## Planning Decisions Committee Meeting

6:30 pm, Tuesday 24 June 2025

<b>Property</b>	98 Nicholson Street, Abbotsford
<b>Ward</b>	Langridge
<b>Application number</b>	PLN25/0031
<b>Proposal</b>	Use of the site as a restricted recreation facility (gymnasium) operating 24 hours, 7 days a week and the associated display of business identification signage (including internally illuminated signage).
<b>Zoning &amp; Overlay/s</b>	<ul style="list-style-type: none"> <li>- Industrial 3 Zone</li> <li>- Development Contributions Plan Overlay - Schedule 1</li> </ul>
<b>Strategic setting</b>	'Industrial Land' in the Strategic Framework Plan
<b>Submissions</b>	9 objections and 4 submissions in support
<b>Key reasons for support</b>	<ul style="list-style-type: none"> <li>- Hours of use are compatible with industrial land</li> <li>- There would be no unreasonable amenity impacts from the use to nearby dwellings</li> <li>- The extent of proposed signage is appropriate to the site and area and will not cause unreasonable amenity impacts to nearby dwellings</li> </ul>

Figure 4 – Proposed ground floor (top) and first floor (lower). Source: decision plans.

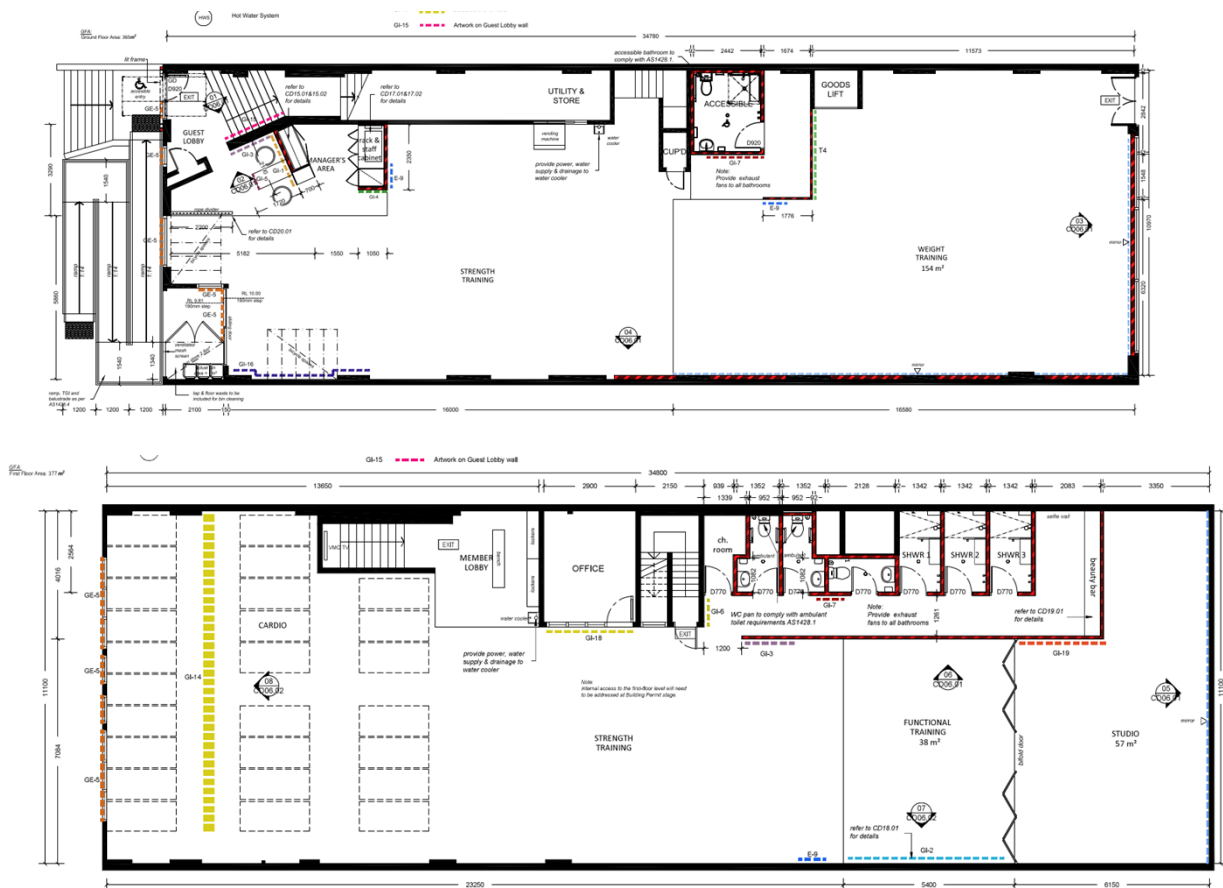
- (d) A notation that the front access ramp does not form part of this planning permit application;
  - (e) The west facing glazing to the bin room to remain closed at all times (except for bin transfer into the site);

- (f) The west elevation updated to show:
    - (i) The front roller door (to the bin storage) open; and
    - (ii) Location of the bin mesh screen, consistent with the proposed ground floor plan.

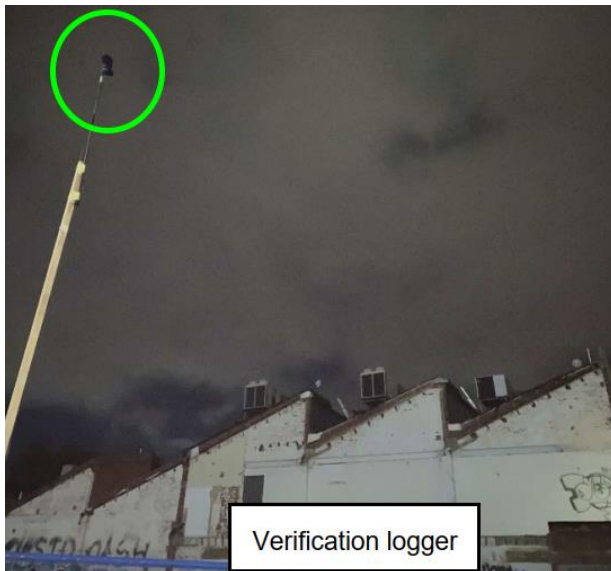
The nearest noise sensitive receivers are identified in the figure shown below (extracted from the acoustic report). 'R1' represents an apartment building at 205 Gipps Street and 'R2' represents a terrace house at 113 Nicholson Street.

*The site location, nearby sensitive receivers and applicant's proposed operations have been identified.*
